Shift Interrupt Plate Replacement

Models Affected: All Hi-Performance 1998 2.5 Race Offshore & 1999 2.5 EFI, 2.5 EFI SS, and 2.5 EFI Offshore Engines Serial Number 0G857103 & Below

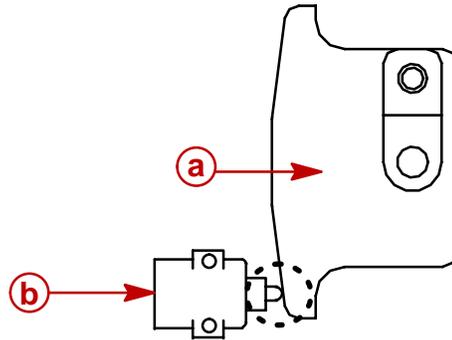
Engine misfires at any RPM up to 80% throttle opening. No misfire above 80% throttle.

Function of Shift Interrupt Switch: To make shifting from in gear to neutral easier, the shift interrupt switch momentarily cuts out cylinders 1–3–5 through the ECM. If the switch is in contact with the plate when in gear, vibration can intermittently activate the cut out function.

Visual inspection: Shift interrupt switch is in contact with plate when in gear.

- a** - Shift Interrupt Plate
- b** - Shift Interrupt Switch In Contact With Plate When In Gear

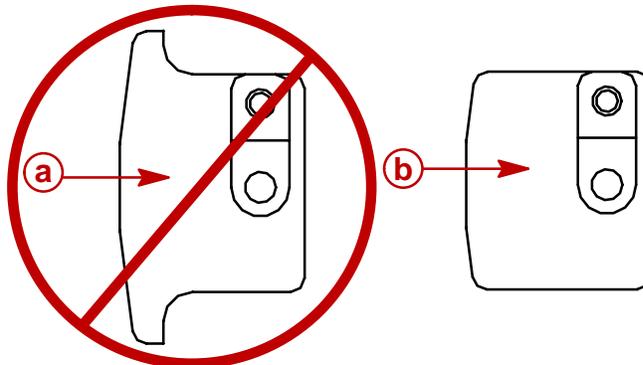
- a** - Original Shift Interrupt Plate
- b** - Shift Interrupt Plate P/N 814284--2

Replace with shift interrupt plate P/N 814284--2
